Access Compliance Report

Public Rights-of-Way

(Curb Ramps)

Intersection ID: 46303	Main Street: HONEY_CREEK_LN	Cross Street: MERMANS_RD	Location: SE
ADA ID: 9FADFA02A4A0	Ramp Type: PerpDiag	Initial Pass/Fail: Fail	Overall Compliance: No
Severity Score: 22.5			
Codes/Mitigation Info/Possible Solution		Field Measurements/Component Compliance

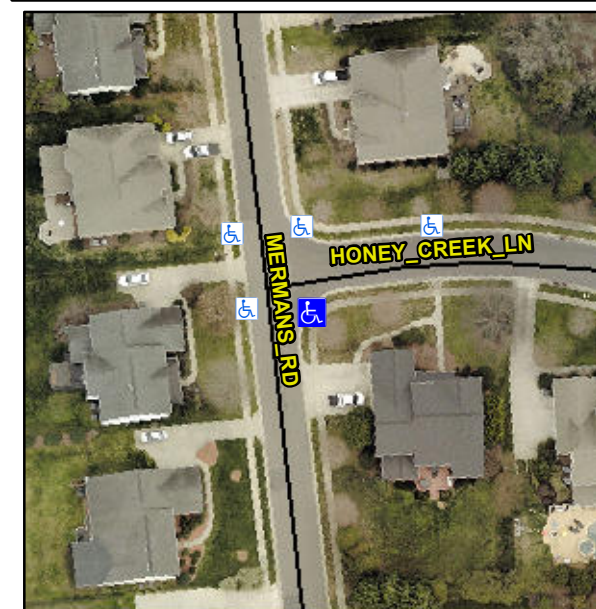
Not Found, R304.5.1, R304.2.2, R304.5.3

Compliance	Description	Data	Compliance	Description	Data
N/A	Ramp Length (in)	48.0	No	Ramp Slope (%)	10.9
No	Ramp Width (in)	47.5	No	Ramp XSlope (%)	2.3
N/A	Flare Type LT	N/A	N/A	Flare Type RT	N/A
N/A	Flare Slope LT (%)	N/A	N/A	Flare Slope RT (%)	N/A
N/A	Flare Traversable LT?	N/A	N/A	Flare Traversable RT?	N/A
N/A	Landing Length (in)	N/A	N/A	DWS Provided?	N/A
N/A	Landing Width (in)	N/A	N/A	DWS Contrast?	N/A
N/A	Landing Slope (%)	N/A	N/A	DWS Length (in)	N/A
N/A	Landing X Slope (%)	N/A	N/A	DWS Full Width?	N/A
N/A	Landing Curb? (Y/N)	N/A	N/A	DWS Offset (in)	N/A
N/A	Shared Landing?	N/A			
N/A	Gutter Ponding?	N/A	N/A	Gutter Slope (%)	N/A
N/A	Gutter Lip Ht (in)	N/A	N/A	Gutter X Slope (%)	N/A
N/A	Painted X Walk1?	No	N/A	Painted X Walk2?	No
	X Walk 1 Direction	To N		X Walk 2 Direction	To W
N/A	X Walk 1 Width (in)	N/A	N/A	X Walk 2 Width (in)	N/A
	X Walk 1 Slope (%)	5.6		X Walk 2 Slope (%)	0.7
	X Walk 1 X Slope (%)	0.6		X Walk 2 X Slope (%)	2.7

N/A	Ramp inside XWalk1?	N/A	N/A	Ramp inside XWalk2?	N/A
	Road Slope (%)	0.4	N/A	Clear Space?	N/A
	Road X Slope (%)	6.6	N/A	Clear Space to XWalk (in)	N/A
N/A	Any Obstructions?	N/A	N/A	Storm Grate/Utility Hazard?	N/A
	Obstruction Type			Storm Grate/Utility Type	
		N/A			N/A
			Yes	Surface Condition? (G/P)	Good

Remove & Replace Curb Ramp With Two New Directional Ramps or Equivalent.
